**RE:** Wellington Prep Plant(C/007/0012): Postmining Land Use Change

Title: Postmining Land Use Change (Redline/Strikeout Version)

# Wellington Preparation Plant (C/007/0012)

### Postmining Land Use Change

E9-3341

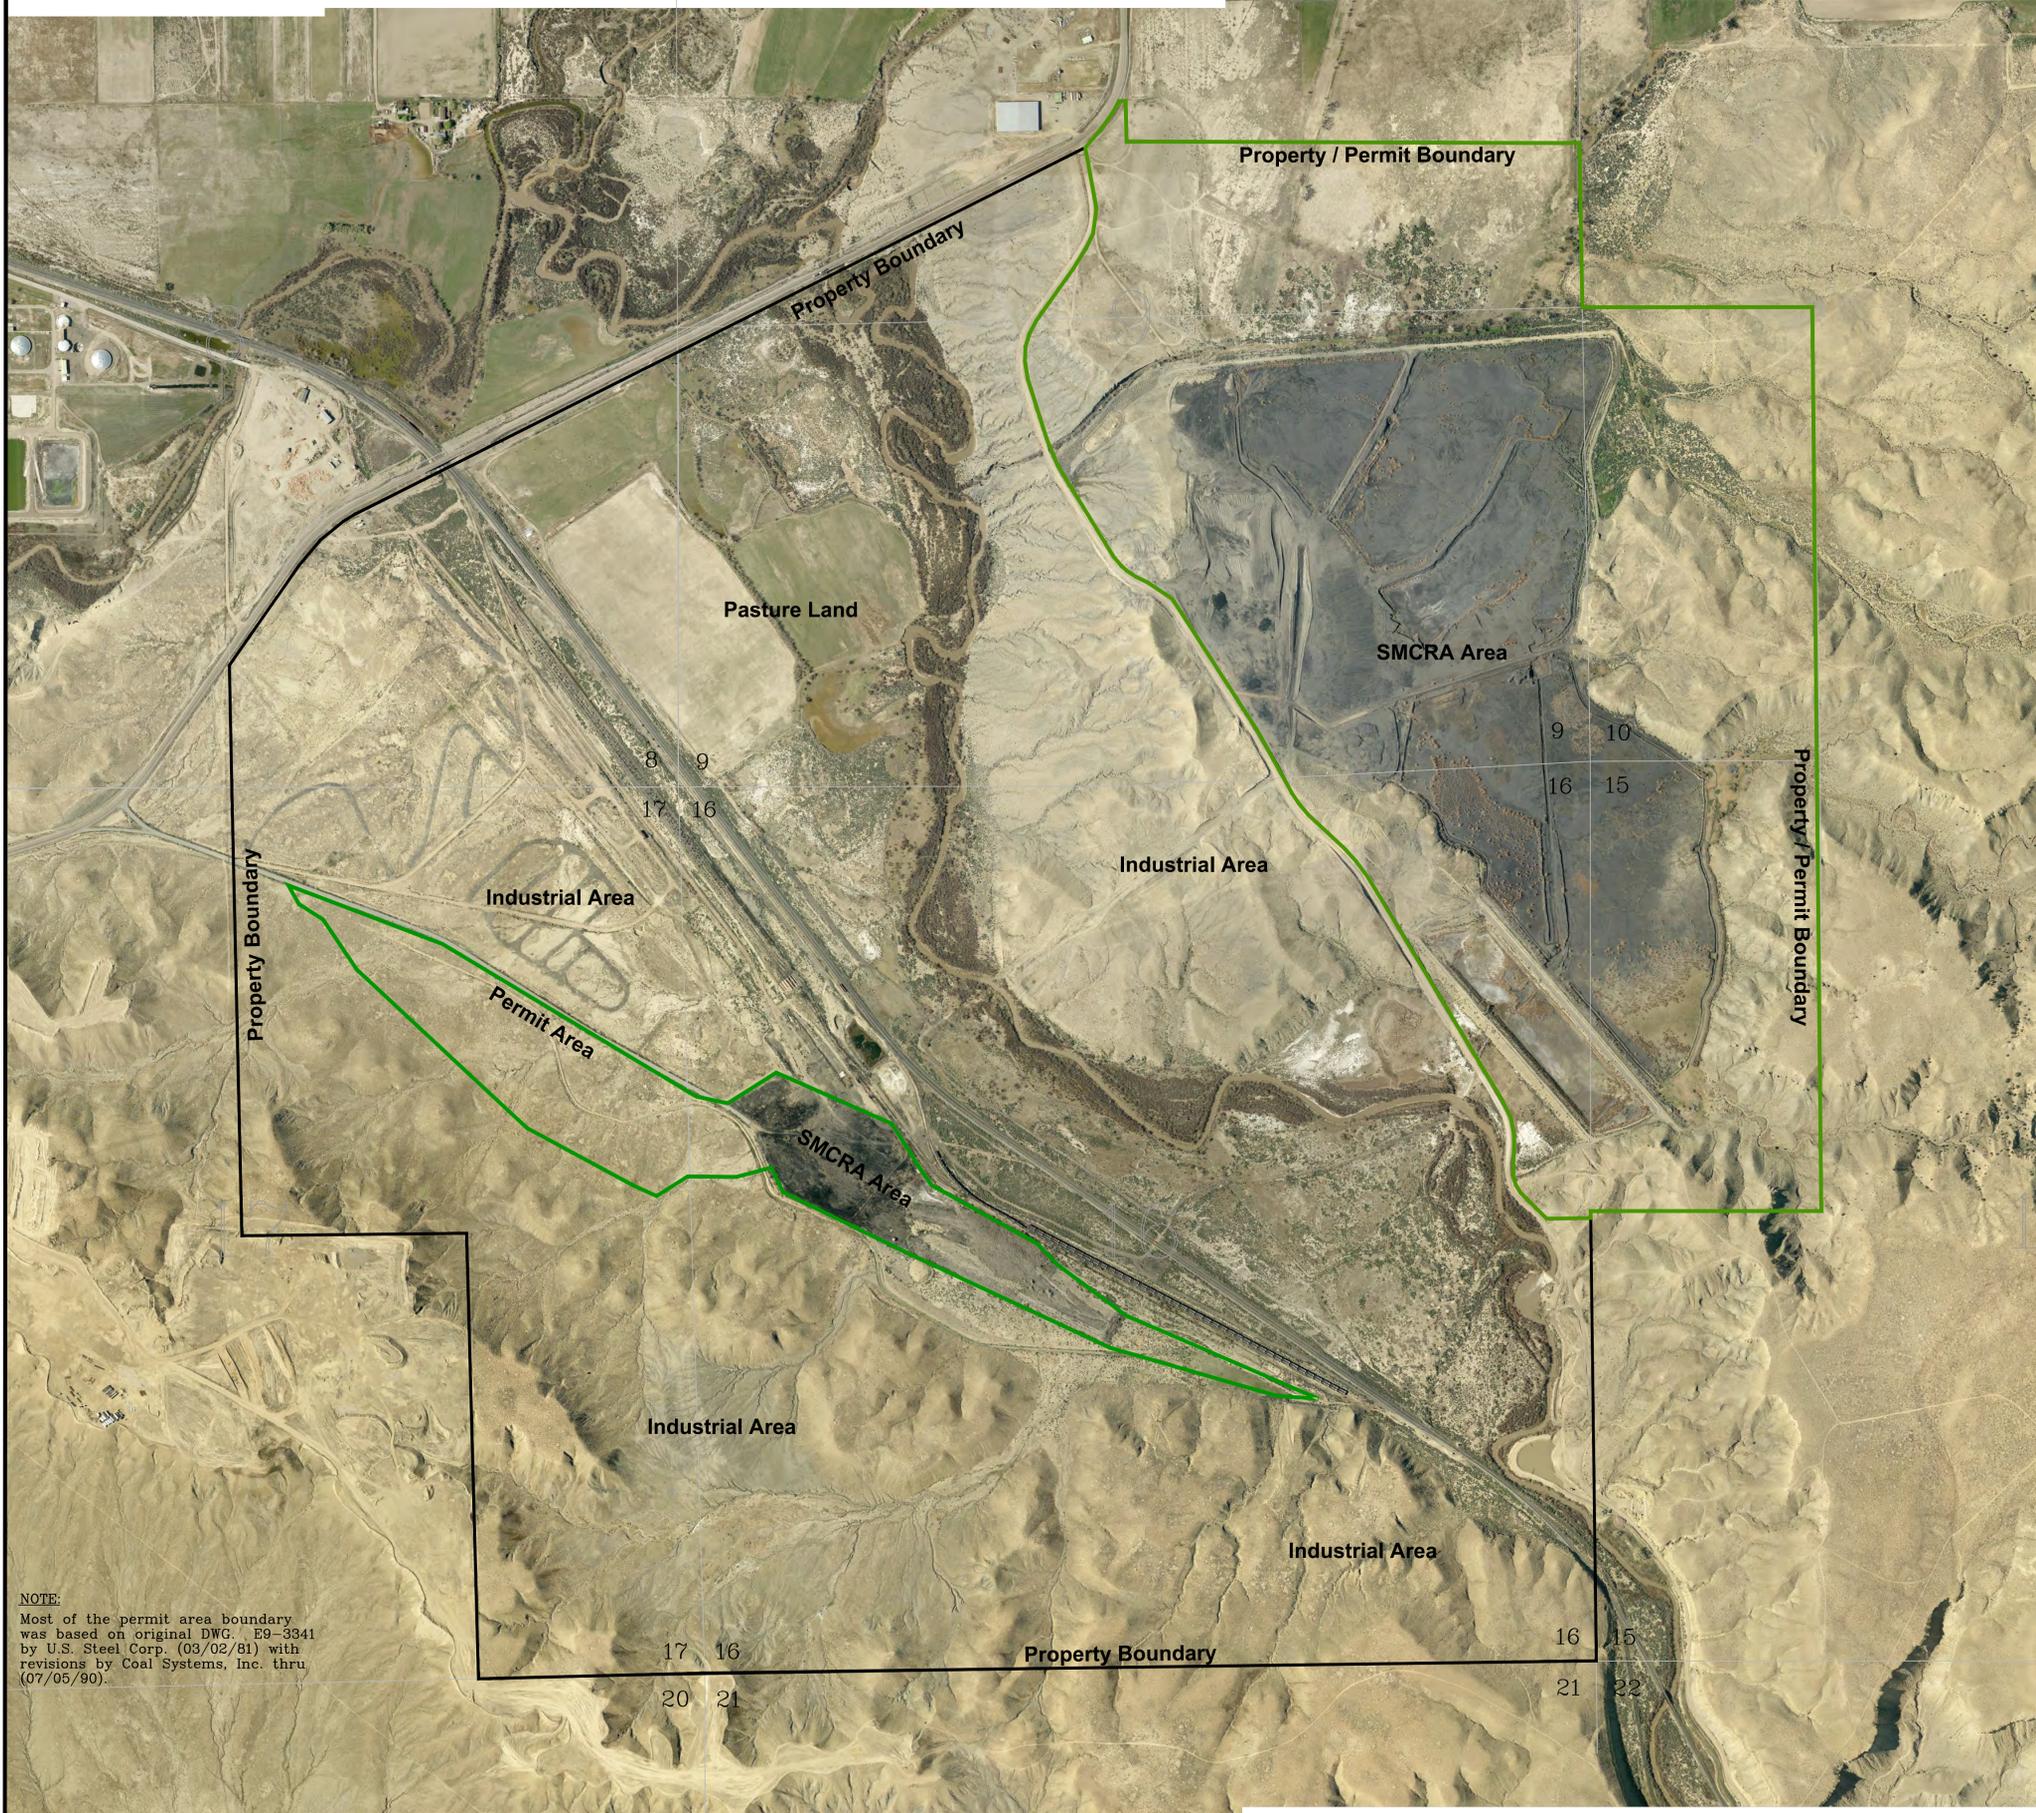
- A. Permit Area, Facilities Map. This has always been the “go-to” map for the Wellington site that identifies specific facilities and areas on the property.
- B. A map has been prepared to show the proposed Current Land Uses; it differentiates between “Industrial” and SMCRA areas.
- C. A new map has also been prepared to show the proposed Postmining Land Use changes along with the new permit area boundaries.
- D. Another map has been provided that shows the Disturbed Areas to be reclaimed through the state R645 rules and federal SMCRA regulations.
- E. A new Hydrologic Monitoring Map that reflects the new monitoring plan has also been provided.
- F. Modifications to the Hydrologic Evaluation Map have been made and included in this submittal.

9. Upon approval of the postmining land use change, the area will be removed from the Wellington Preparation Plant's Mining and Reclamation Plan (ACT/007/0012). The new permit area boundaries have been revised and are shown on Dwg. E9-3341. An application for a partial bond release will be submitted at that time.

E9-3343(1)

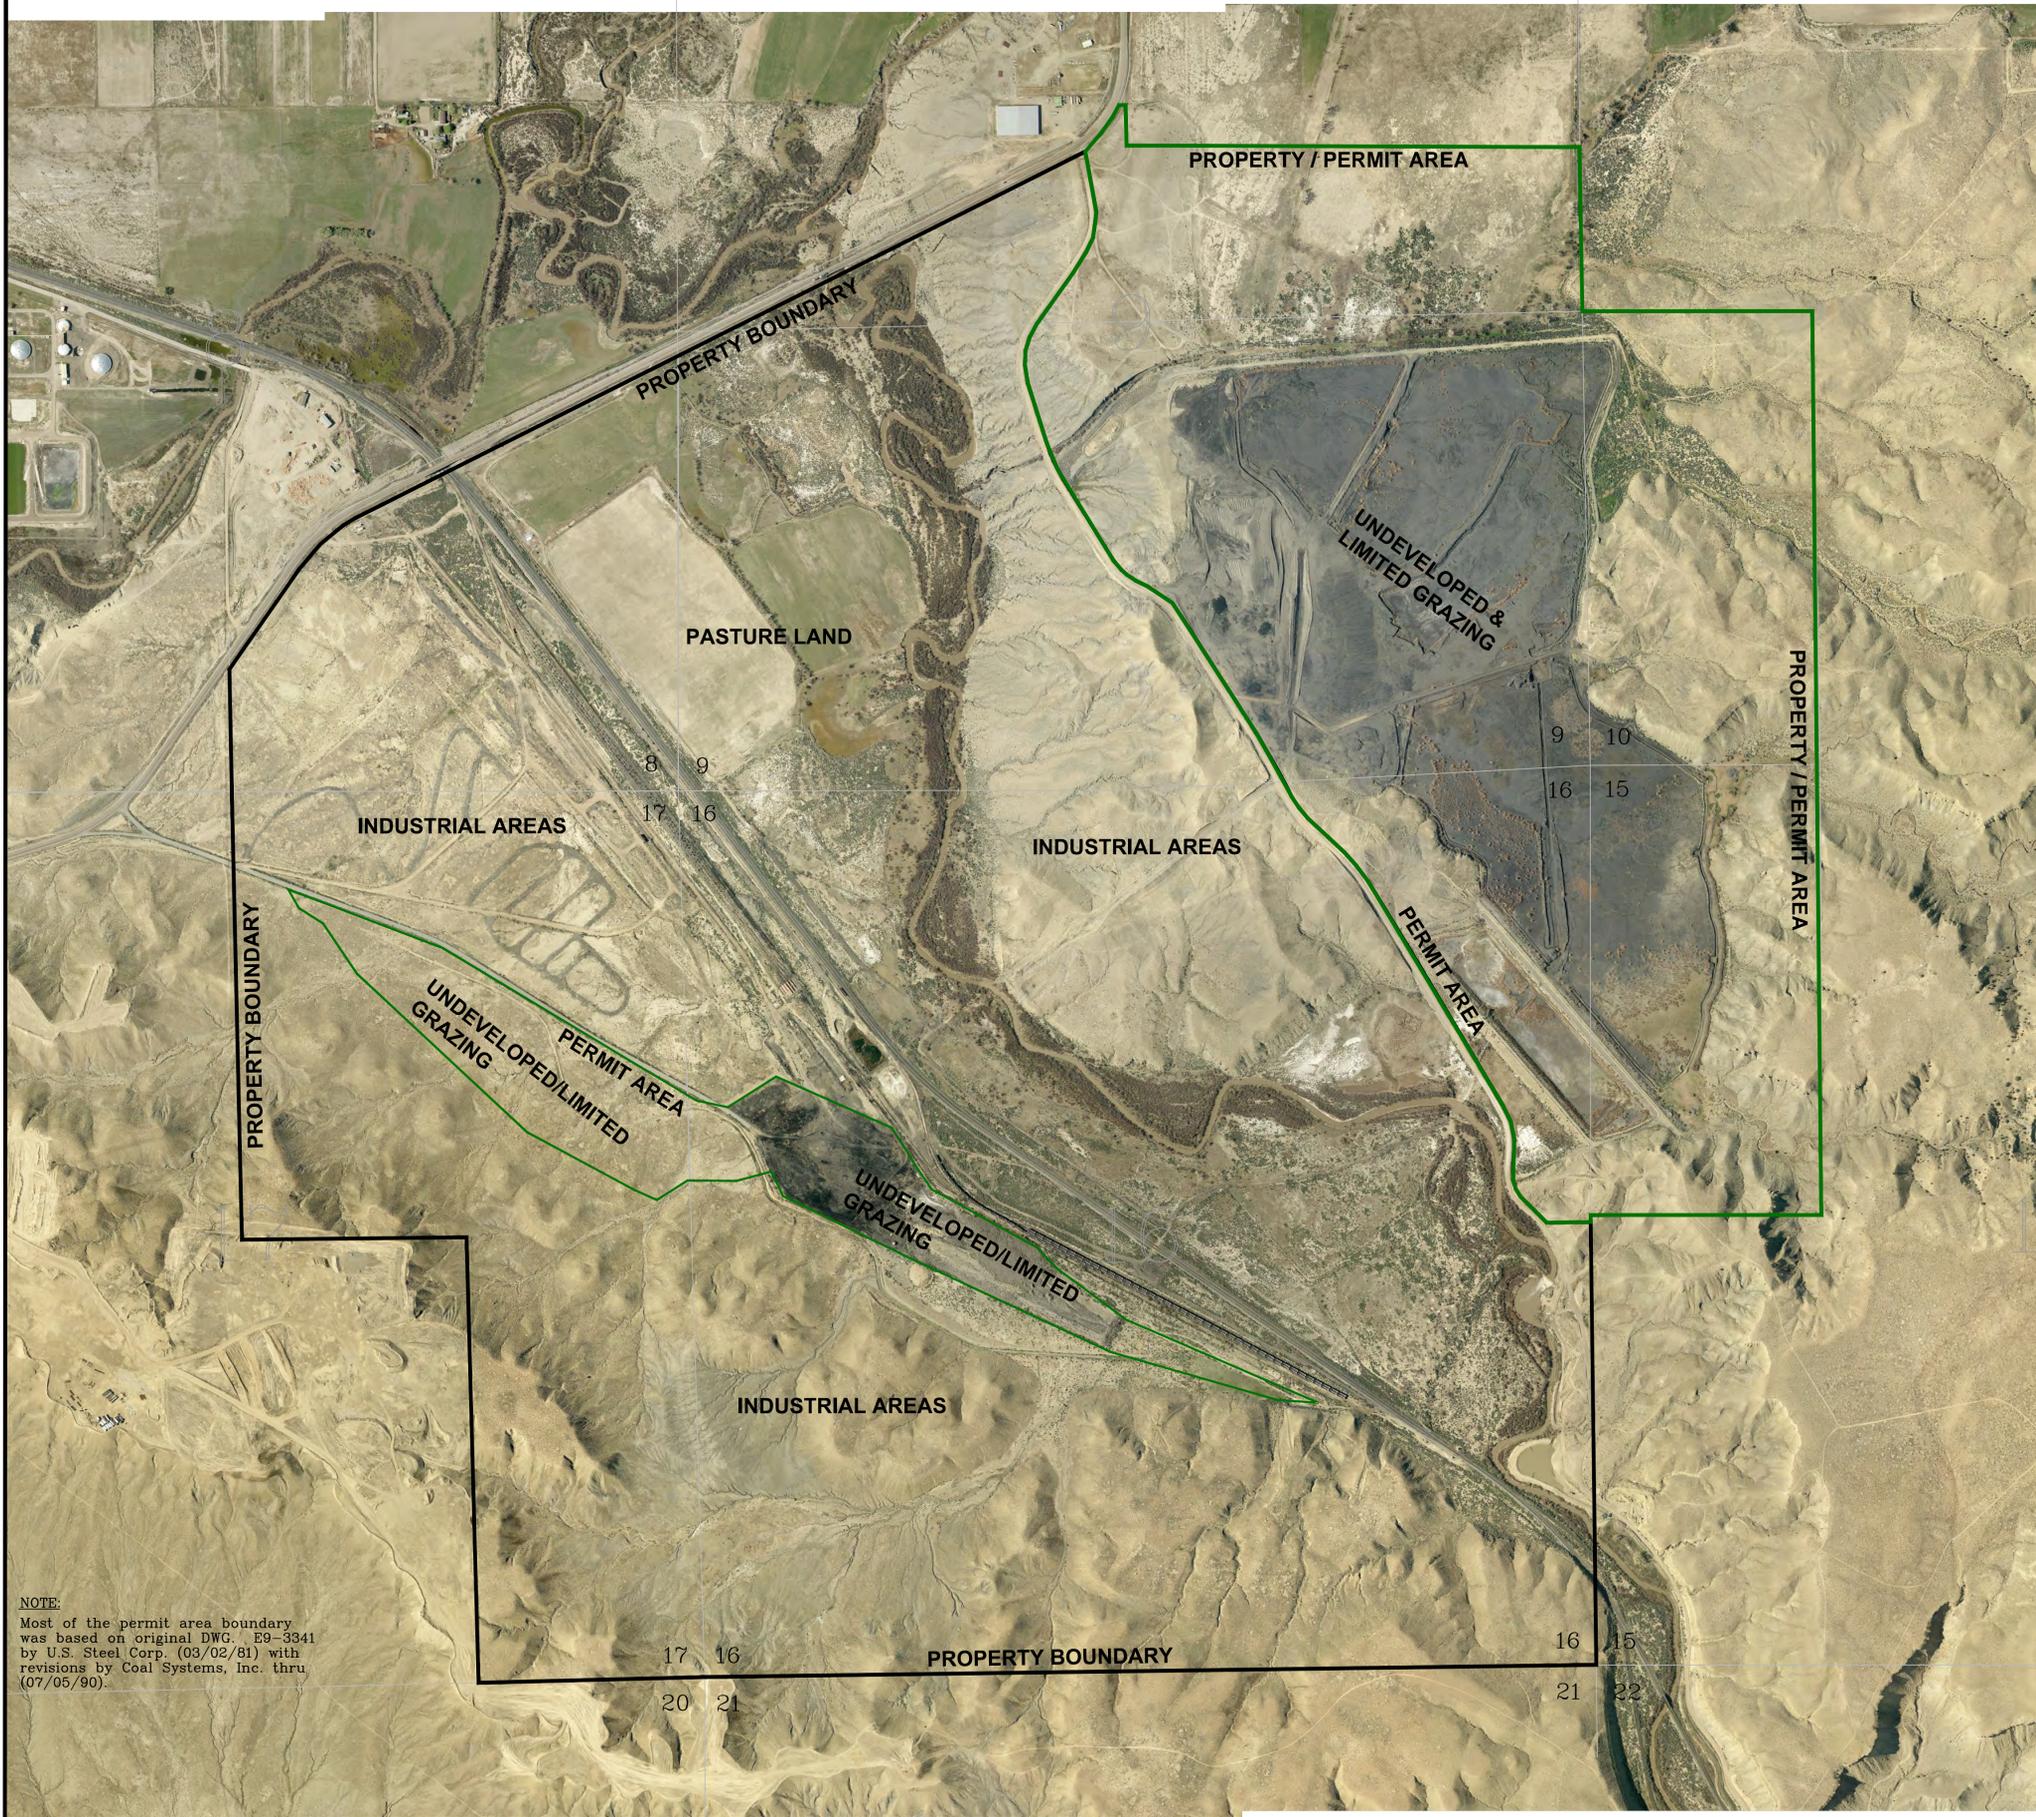
*Cultivated Lands* - As mentioned previously, much of the disturbed land at the Wellington Preparation Plant will be returned to "undeveloped land with limited grazing". One exception is an area that is presently cultivated lands. This area is irrigated and presently functioning as crop- and pasture-lands. This area will also be used as similarly following final reclamation. The area has been shown on a map previously submitted to the State of Utah, Division of Oil, Gas & Mining (see Dwg. E9-3343).

The crops planted vary from year to year and are sometimes rest/rotated. The primary crops planted have been alfalfa, corn and pasture grasses (see Section 4.11). This is expected to continue in the future for postmining land. As an average, the postmining standard for annual crop production should be approximately 6,500 lbs. per acre for alfalfa and 5,500 lbs. per acre for corn and 3,000 lbs per acre for pasture grasses. For a map showing existing cultivated land, refer to Dwg. E9-3343.
